**SERVICE BULLETIN SB FSG2T-1.05**

**TYPE DESIGNATION** FSG 2T VHF/AM Airband Transceiver – Part number F10350

**APPLICABILITY** This Service Bulletin may be introduced to all FSG 2T VHF/AM transceivers having serial number 35X-05100 up to serial number 35X-06492, if not marked with Mod-Index **SB 1.05**.

Fig. 1: TX/RX Module before modification

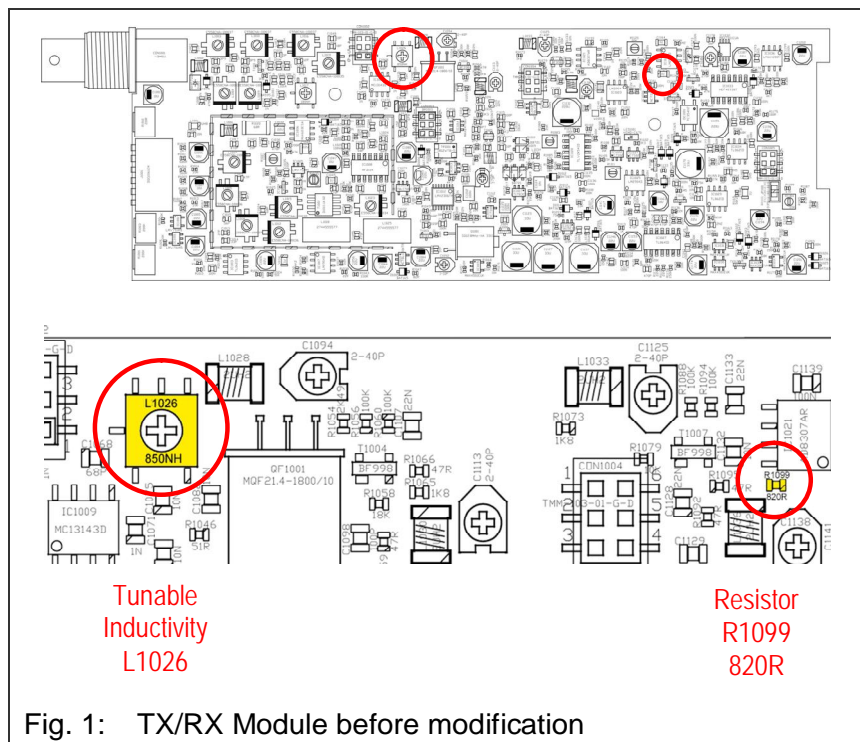
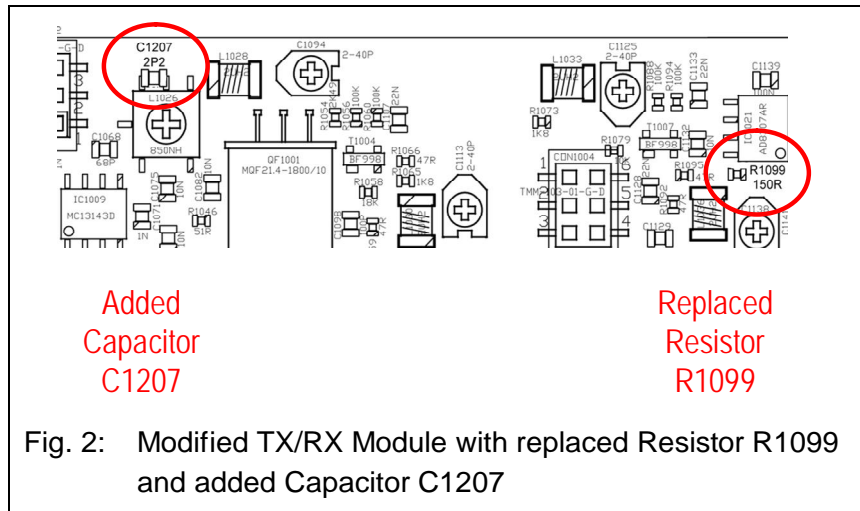
**DESCRIPTION** Verify reliable communication in the vicinity of external RF transmitters, which could disturb active communication channels. Improvement against external RF signal, exceeding the maximum limits, can be achieved by modifying the resistor R1099 and to introduce the capacitor C1207 on the TX/RX module.

Locate the resistor R1099 (820R) and the tunable inductivity L1026 on the TX/RX Module.

Repair: Replacing the Resistor R1099/820R by a Resistor R1099/150R:

- Use an adequate solder tip to unsolder the 820R Resistor.
- Clean the soldering pads.
- Take the supplied NEW Resistor R1099, 150R, and position it.
- Use an adequate solder tip and solder.

Adding a Capacitor C1207:

- Take the supplied NEW Capacitor C1207, 2P2, and position it across the two upper left soldering pads of the inductivity L1026.
- Use an adequate solder tip and solder.

Fig. 3: Position of Mod-Index Label

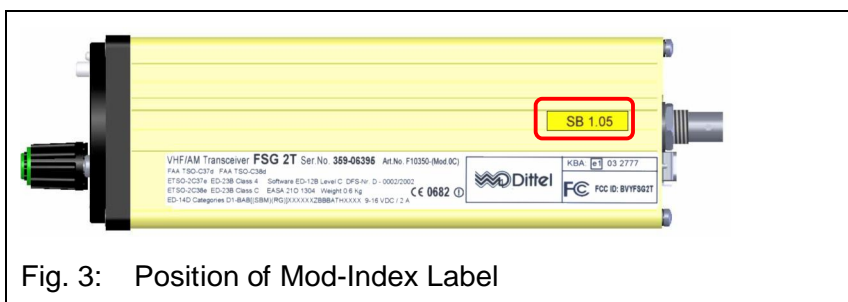
After meeting the required minimum performance values mark the transceiver FSG 2T with the supplied Mod-Index label

**SB 1.05**
